# Access Compliance Report

## Public Rights-of-Way

Intersection ID: 31545	Main Street: ADA_CT	Cross Street: CALDWELL_RIDGE_PY	Location: W
ADA ID: 487BC0338131	Ramp Type: PerpDiag	Initial Pass/Fail: Fail	Overall Compliance: No
Codes/Mitigation Info/Possible Solution		Field Measurements/Component Compliance

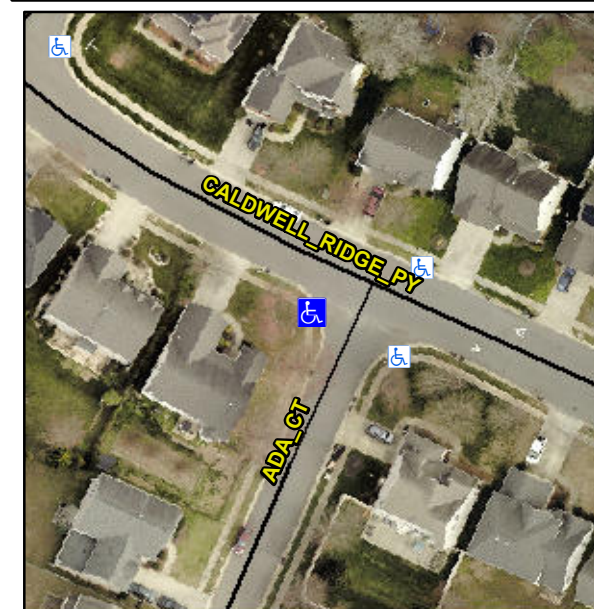
**Not Found, R304.5.1, R304.2.2**

Compliance	Description	Data	Compliance	Description	Data
N/A	Ramp Length (in)	45.0	No	Ramp Slope (%)	9.1
No	Ramp Width (in)	47.0	Yes	Ramp XSlope (%)	1.1
N/A	Flare Type LT	N/A	N/A	Flare Type RT	N/A
N/A	Flare Slope LT (%)	N/A	N/A	Flare Slope RT (%)	N/A
N/A	Flare Traversable LT?	N/A	N/A	Flare Traversable RT?	N/A
N/A	Landing Length (in)	N/A	N/A	DWS Provided?	N/A
N/A	Landing Width (in)	N/A	N/A	DWS Contrast?	N/A
N/A	Landing Slope (%)	N/A	N/A	DWS Length (in)	N/A
N/A	Landing X Slope (%)	N/A	N/A	DWS Full Width?	N/A
N/A	Landing Curb? (Y/N)	N/A	N/A	DWS Offset (in)	N/A
N/A	Shared Landing?	N/A			
N/A	Gutter Ponding?	N/A	N/A	Gutter Slope (%)	N/A
N/A	Gutter Lip Ht (in)	N/A	N/A	Gutter X Slope (%)	N/A
N/A	Painted X Walk1?	No	N/A	Painted X Walk2?	No
	X Walk 1 Direction	To SE		X Walk 2 Direction	To N
N/A	X Walk 1 Width (in)	N/A	N/A	X Walk 2 Width (in)	N/A
	X Walk 1 Slope (%)	2.4		X Walk 2 Slope (%)	1.1
	X Walk 1 X Slope (%)	1.2		X Walk 2 X Slope (%)	1.7

**Remove & Replace Curb Ramp With Two New Directional Ramps or Equivalent.**
